SI B61 11 16
General Electrical Systems

THE CHARGING CABLE DOES NOT RELEASE FROM THE CHARGING SOCKET AFTER CHARGING

This Service Information bulletin supersedes SI B61 11 16 dated **September 2016**

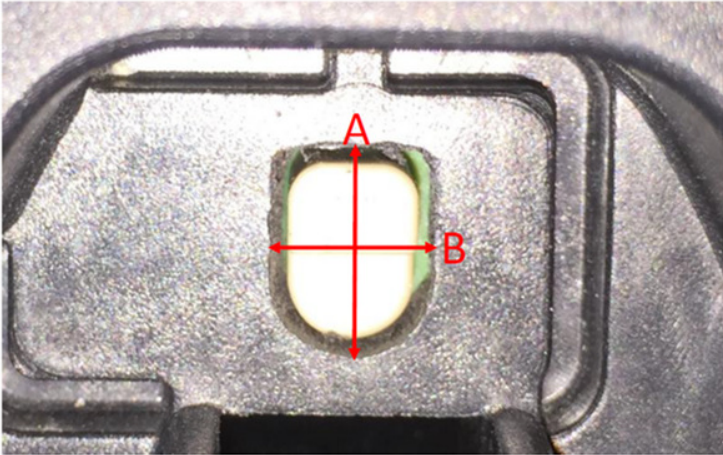
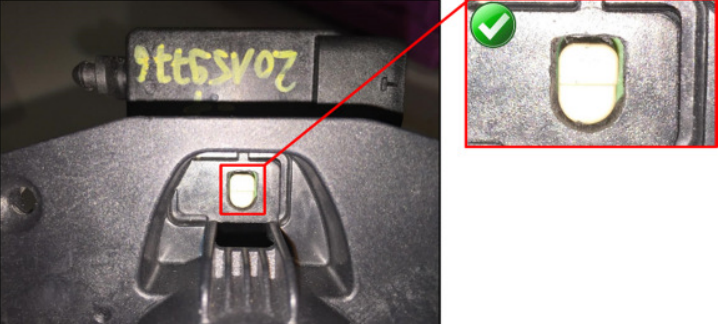
The following tools will be needed in order to perform this repair. A. 5 Star safety socket bit or wrench B. Vernier Caliper C. File
	1. Visually inspect the actuator lock pin to see if it is binding in the hole in the highlighted areas as shown. The actuator pin should move easily when activated. 2. Did you find evidence of binding? YES- continue with Step 2. NO – diagnose with ISTA for charging system-related faults.
	3. Remove the actuator for the charging socket as per ISTA Repair instructions "67 11 595". Note: Use the 5 star safety bit to remove the 4 mounting screws. Note: Before starting the modification of the actuator pin hole (step 3), ensure that the covers are in place to prevent debris from entering the charging port.
	Note: When using the file to enlarge the hole, be careful not to come in contact with any carbon body panel.

4. File the opening of the pin hole to the following diameter (measure with a Vernier caliper): A = 7.9 mm – 8.3 mm B = 5.8 mm – 6.0 mm Note: the rounded corners must still be in place. It is important that the original shape of the hole be preserved. Make sure that the edges are deburred and all filing debris removed.
	The graphics shown are examples of a good rework and poor reworks.
	5. After the modification is complete, reinstall the actuator for the charging socket as per ISTA Repair instructions "67 11 595". Note: Use the 5 star safety bit to tighten the 4 mounting screws to 1.2 Nm.
